Access Compliance Report Public Rights-of-Way (Curb Ramps)

Main Street: HYDE_PARK_DR Cross Street: COVENTRY_PL Location: NE

ADA ID: RPRK211013105011 Ramp Type: Type 4 - Parallel Initial Pass/Fail: Fail Overall Compliance: No Severity Score: 45

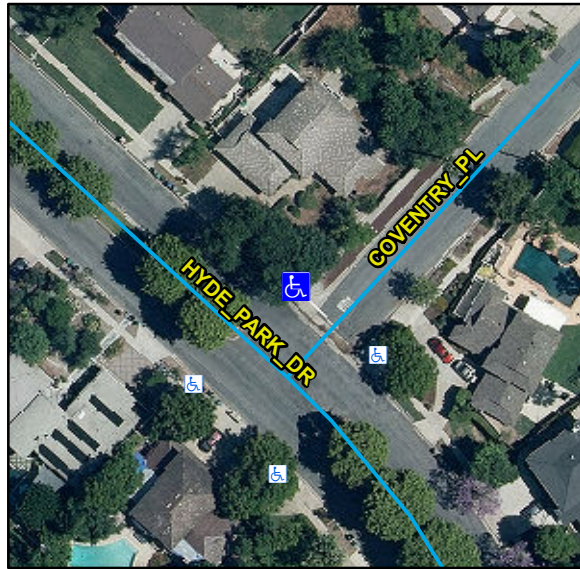
Compliance	Description	Data	Compliance	Description	Data
N/A	Ramp Length LT (in)	120	N/A	Ramp Length RT (in)	119
Yes	Ramp Width LT (in)	125	Yes	Ramp Width RT (in)	128
Yes	Ramp Run Slope LT (%)	2.5	No	Ramp Run Slope RT (%)	12.9
No	Ramp Cross Slope LT (%)	6.1	No	Ramp Cross Slope RT (%)	4
N/A	Landing Present	N/A	N/A	DWS Provided	N/A
N/A	Landing Length (in)	N/A	N/A	DWS Contrast	N/A
N/A	Landing Width (in)	N/A	N/A	DWS Length (in)	N/A
N/A	Landing Run Slope (%)	N/A	N/A	DWS Full Width	N/A
N/A	Landing Cross Slope (%)	N/A		DWS Offset Type	N/A
N/A	Landing Movement Obstructed?	N/A	N/A	DWS Offset Left (in)	N/A
	Landing Movement Type	N/A	N/A	DWS Offset Right (in)	N/A
N/A	Landing Shared	N/A			
N/A	Clear Space	Yes			
N/A	Clear Space To Crosswalk (in)	N/A			
N/A	Marked Crosswalk 1	No	N/A	Marked Crosswalk 2	No
	Crossing 1 Direction	SW		Crossing 2 Direction	SE
N/A	Marked Crosswalk 1 Width (in)	N/A		Marked Crosswalk 2 Width (in)	N/A

N/A	Ramp Inside Crosswalk 1	N/A	N/A	Ramp Inside Crosswalk 2	N/A
	Crossing 1 Slope (%)	3.3		Crossing 2 Slope (%)	4.7
	Crossing 1 Cross Slope (%)	1.4		Crossing 2 Cross Slope (%)	6.5
N/A	Gutter Ponding	N/A	N/A	Curb Slope	10.1
No	Gutter Lip Height (in)	0.25		Road Run Slope (%)	5.7
N/A	Gutter Run Slope (%)	N/A		Road Cross Slope (%)	2.3
N/A	Gutter Cross Slope (%)	N/A	Yes	Perpendicular Joint Present	Yes
Yes	Overall Surface Condition	Acceptable			
	Cross Gutter Present?	Yes		Spandrel Present?	Yes
	Replace Cross Gutter?	No		Replace Spandrel?	No

Remove & Replace Curb Ramp With Two New Directional Ramps or Equivalent. Grind Gutter Lip.
